**AGENDA**  
**CITY OF MONTEVALLO**  
**PLANNING AND ZONING COMMISSION**

# REPORT TO THE CITY OF MONTEVALLO

SD20-008

### Lexington Parc– Amended Master Plan

Proposed Amended Master Plan

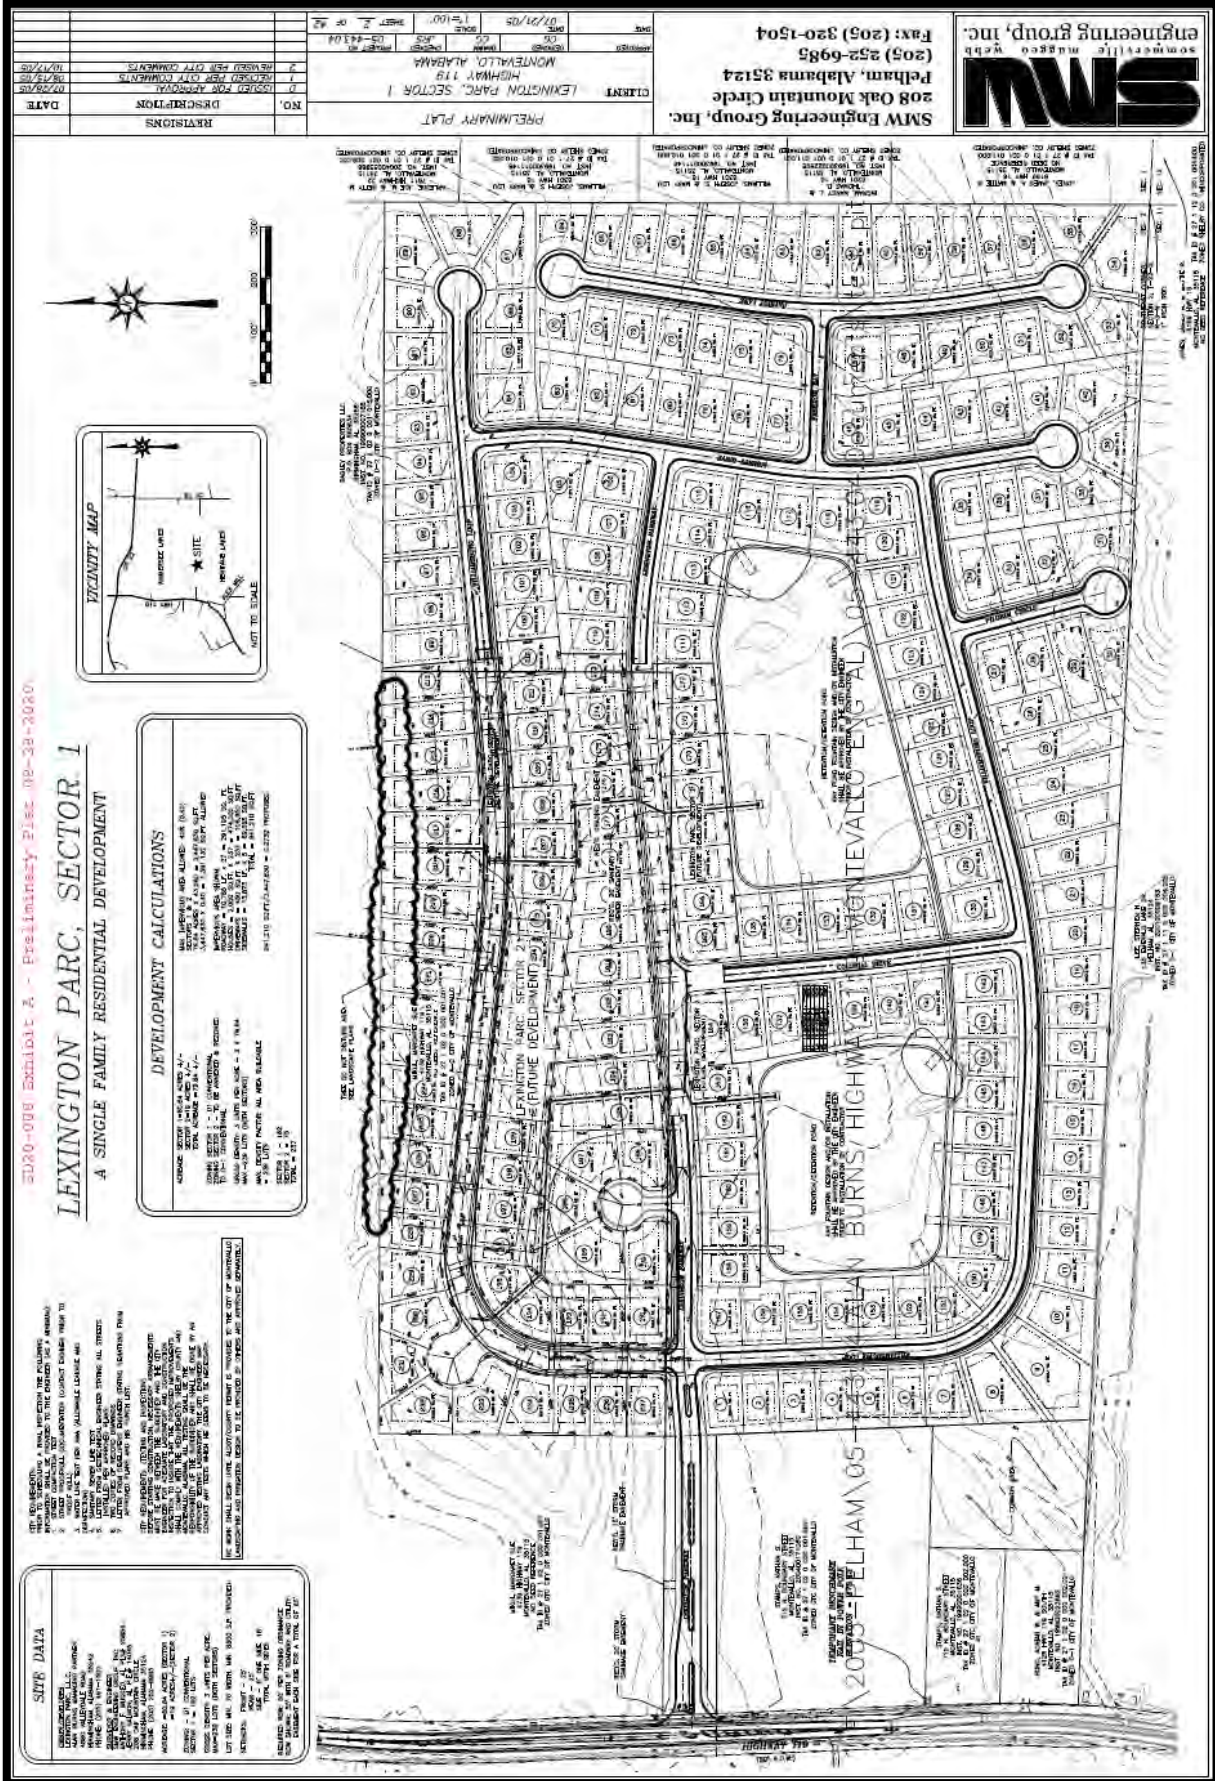
The Amended Master Plan shows two changes to the road layout approved in 2005 for Lexington Parc. The first cul-de-sac off Pilgrim Lane is proposed to be shortened and will gain one lot; and Freedom Parkway is proposed to connect to the unnamed cul-de-sac to the south. New phases will utilize internal circulation previous approved in the 2005 Master Plan.

The approved 2005 Master Plan identified storm water detention as the primary open space. The Amended Master Plan proposes the addition of a park with walking trails and a gazebo, located around the second detention pond. The total amount of open space included in the Amended Master Plan for Lexington Parc includes approximately two acres of passive recreation areas.

The total impervious surfaces of the development including the proposed changes is approximately 28.8 percent; a 1.5 percent increase from the approved 2005 Master Plan. The additional 21 lots is an 8 percent increase to the total lot count.

**SITE GRADING & DRAINAGE PLAN**

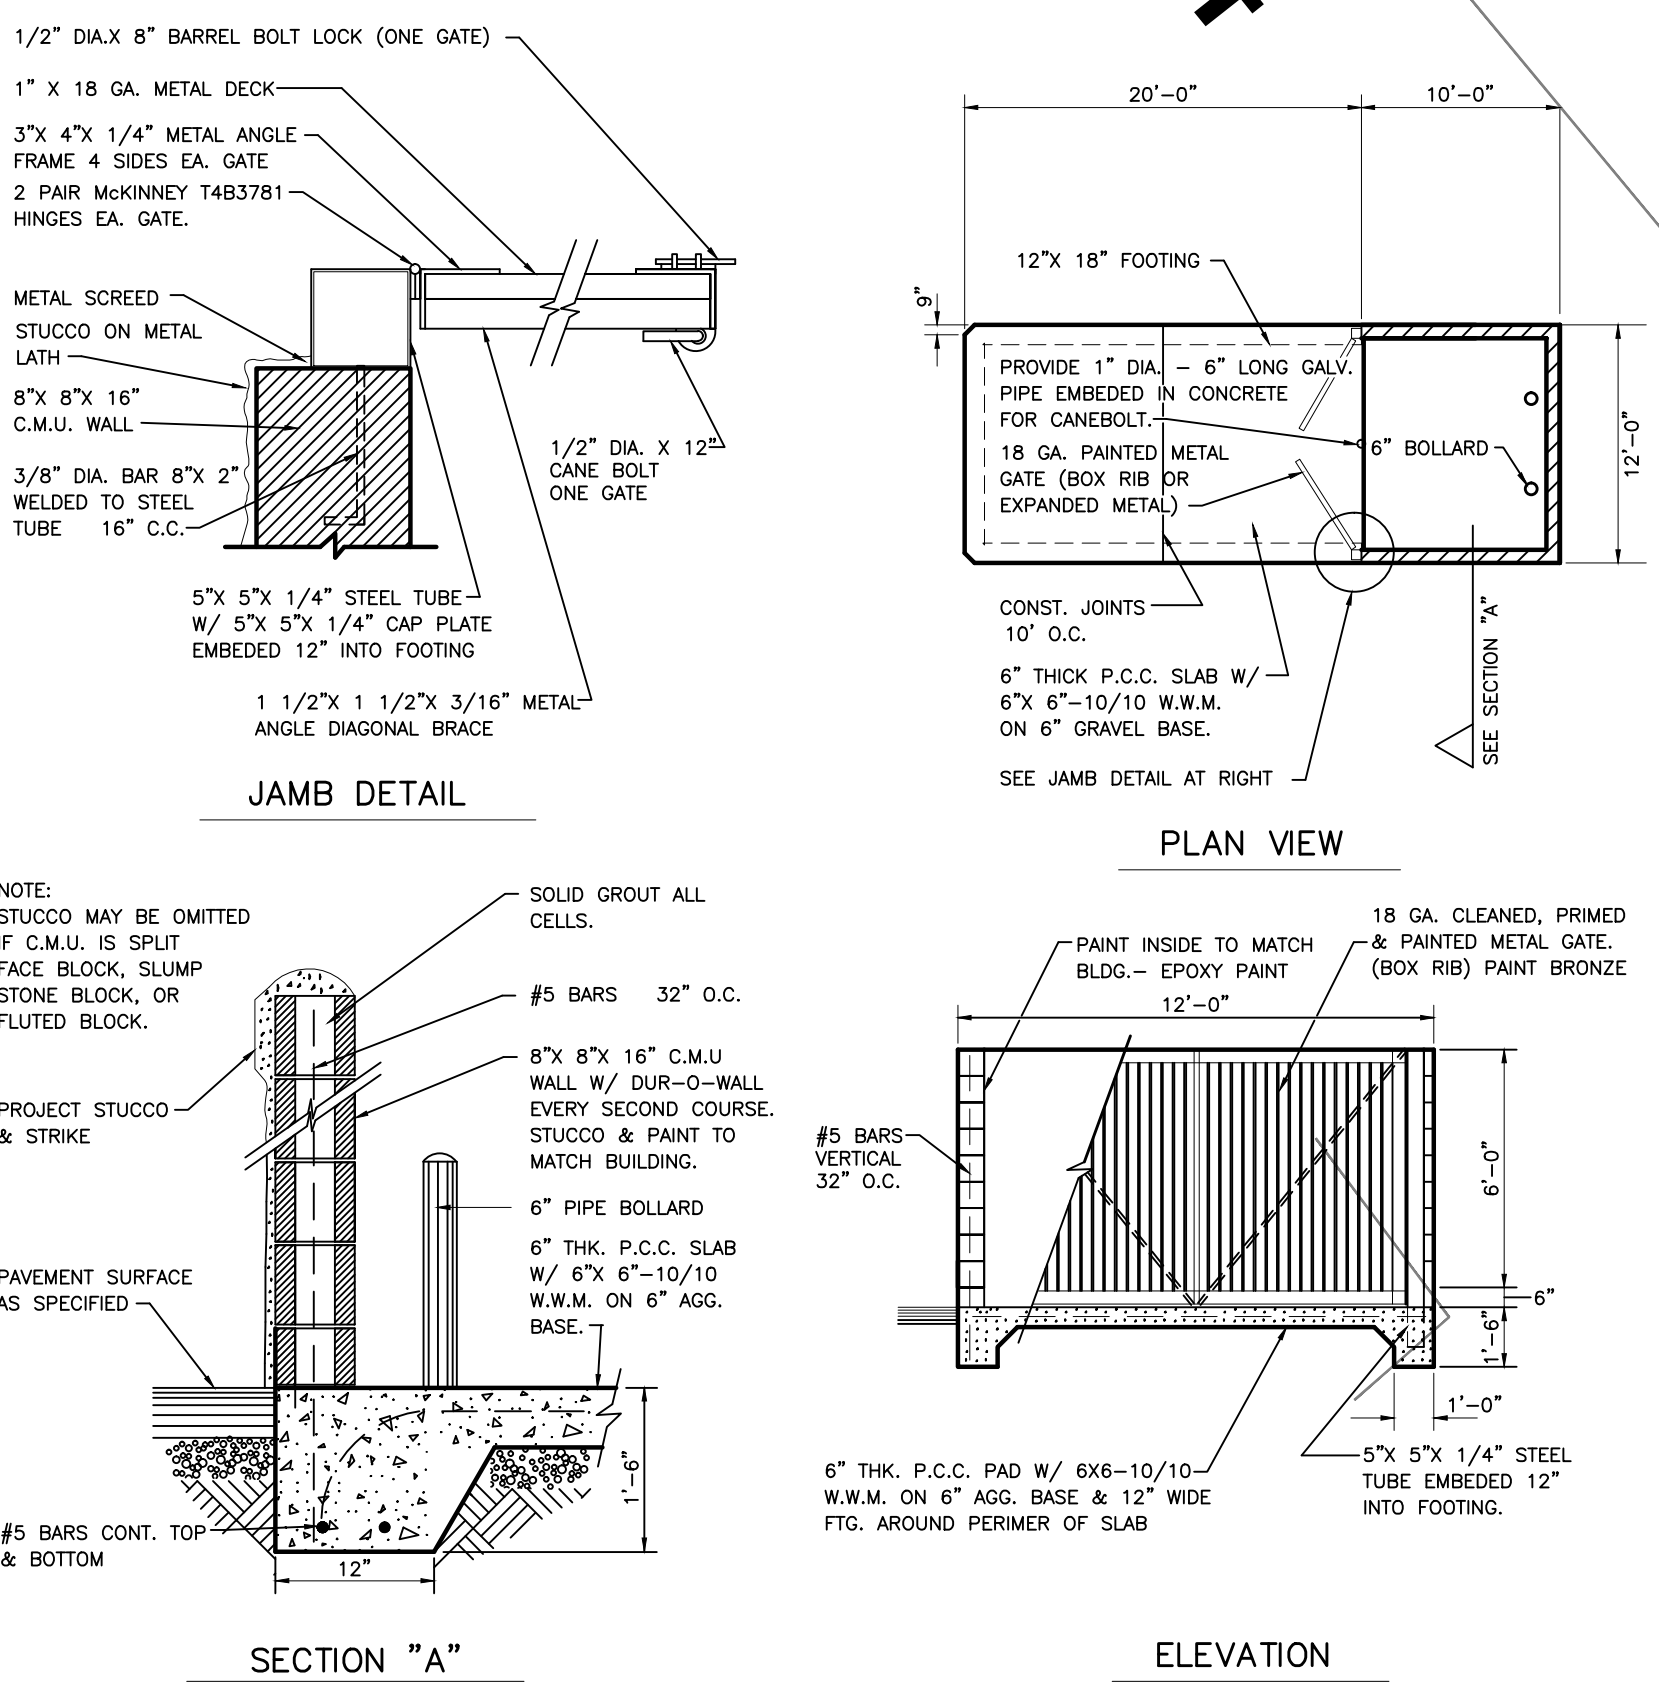
1. The site Data Table on the cover sheet still does not outline all applicable impervious surfaces as to match Sheet C-2.
2. Reference is made to “Retail” parking and its associated floor space requirements; the proposed land use is “Restaurant”. Please update the parking standard with the correct use and required off street parking equation as outlined in the city of Montevallo Zoning Ordinance. Prior to final certification of the site development plan the following items must be added to the plan set.

**SITE UTILITY PLAN**

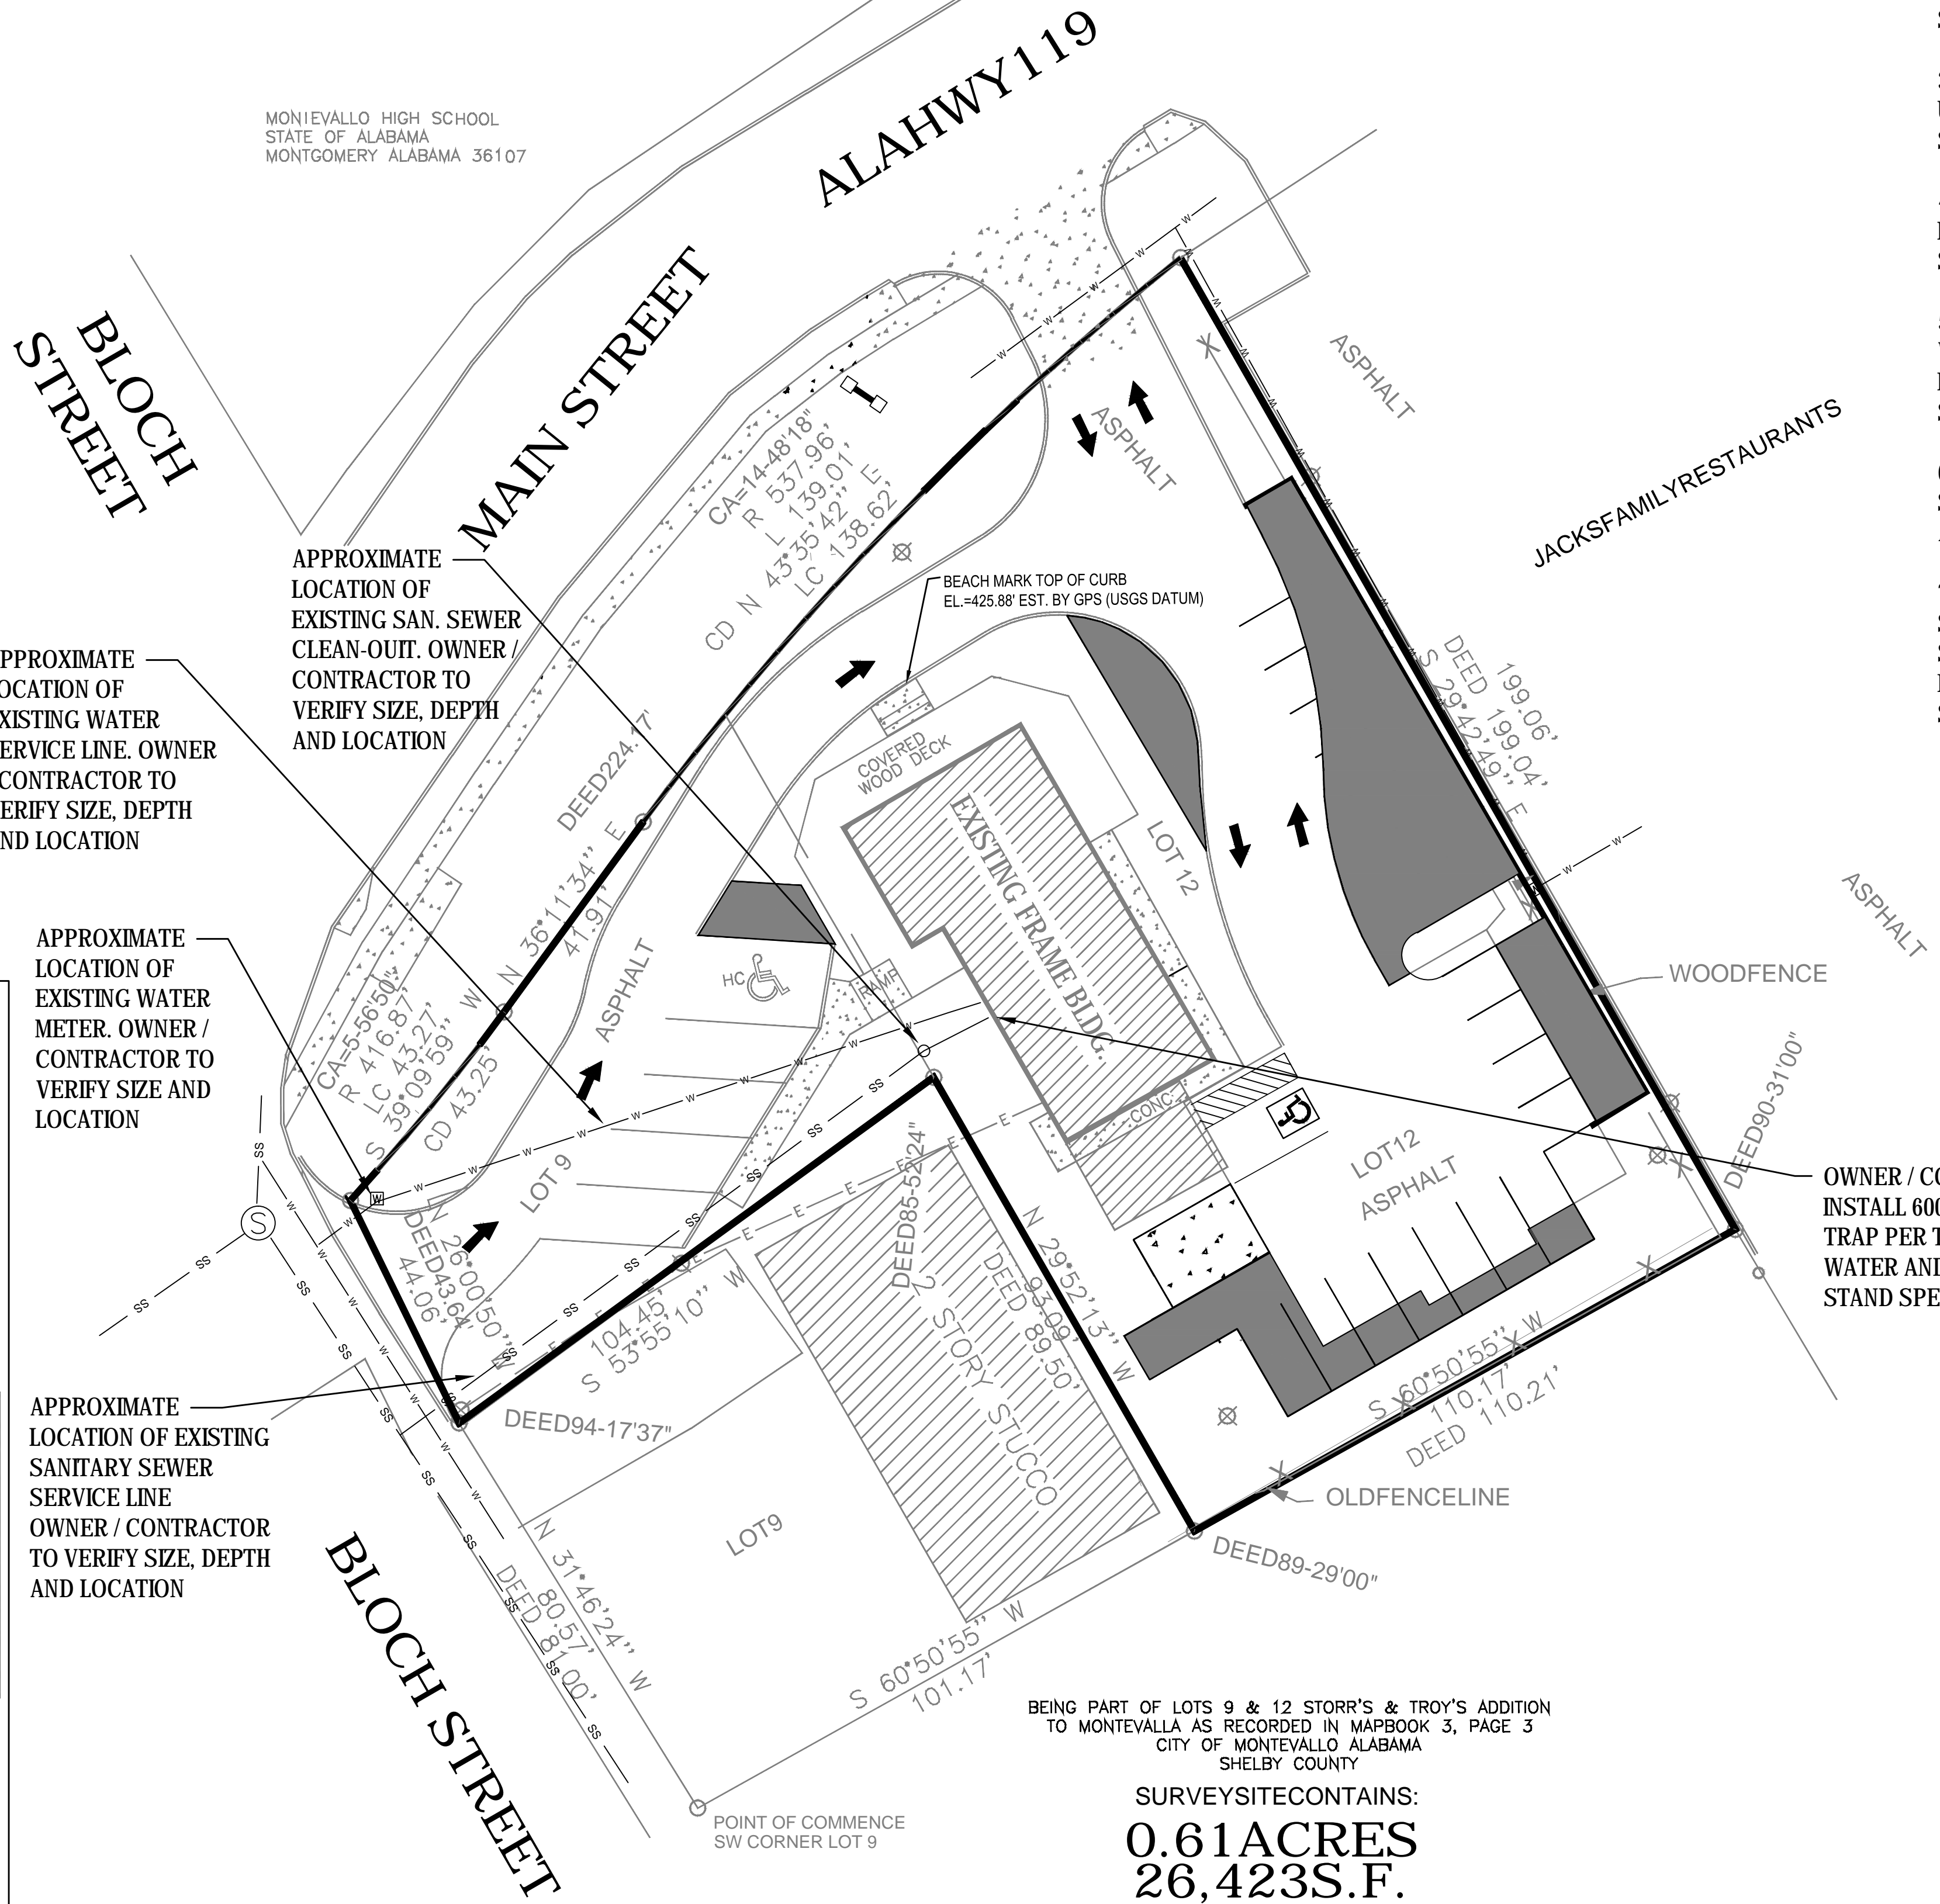
Montevallo Water Works and Sewer Board has completed a review of the plans (dated 10/5/20) and have provided a conditional approval based on the addition of the following notes to the site plan set:

- a) Please provide benchmark per Montevallo Water and Sewer Board Standard Sanitary Sewer Specifications and Potable Water Specification.
- b) Provide documentation from Mechanical Engineer that existing water service is sufficient for water service and peak flow demand.
- c) Grease trap shall be sized in accordance with the Plumbing and Drainage Institute Standard PDI-G101 as outlined within the Montevallo Water and Sewer Board Standard Sanitary Sewer Specifications.
- d) Montevallo Water and Sewer Board representative shall be present when any work is performed on the water system and/or the sewer system.
- e) All work on the water system and the sewer system must be performed by a licensed contractor.
